# 1966 Corvette: Service Bulletin: Air Pump Noise - Air Injection Reactor System

**Bulletin No:** TSB #66-62

**Date:** May 20, 1966

## Date Code

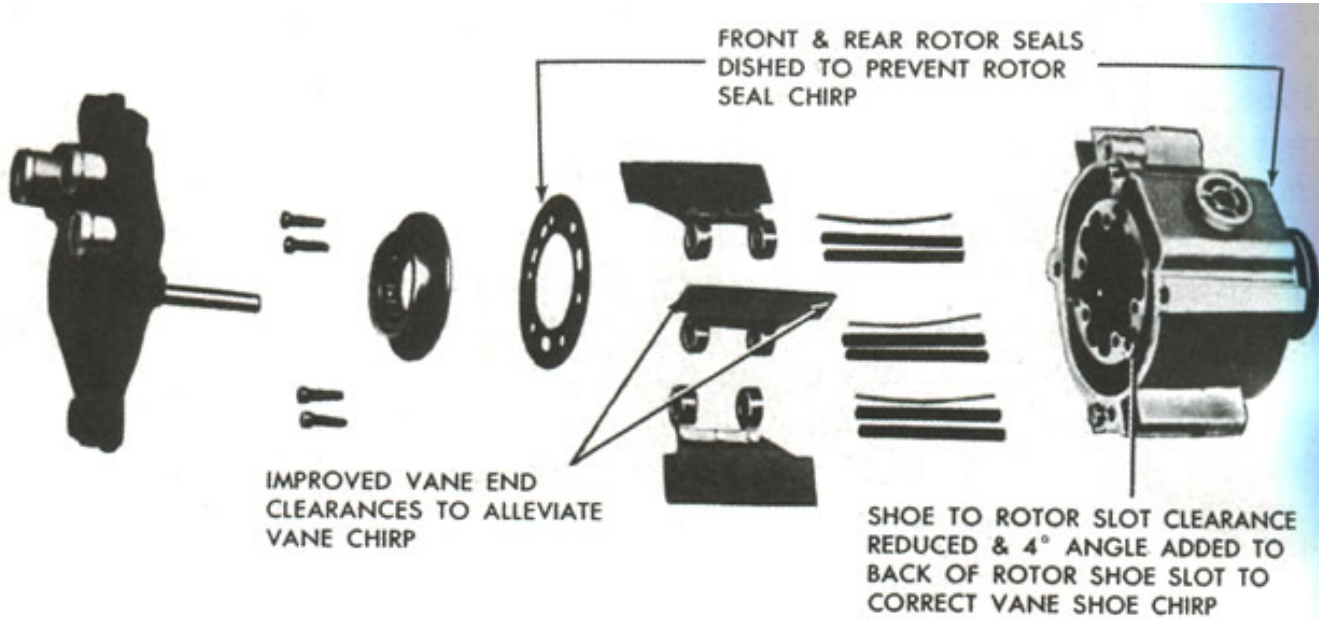
An objectionable "chirping" noise in the air pump may be noted on early units equipped with an Air Injection Reactor System. This noise may be due to the vane ends rubbing the housing and the rear cover, vane shoe vibration, and/or vibration of the rotor seals under light back pressure conditions.

In production, beginning with date code 0126XX stamped on the pump housing, improvements have been incorporated as noted on page 2, to alleviate the above conditions.

If upon completion of the above, the "chirp" still persists, or if the "chirp" is heard at higher pump speeds, the entire pump assembly must be replaced with a pump having a date code of 0126XX or later. Control of pump service components is such that there is no identifying feature to indicate the latest improvements.
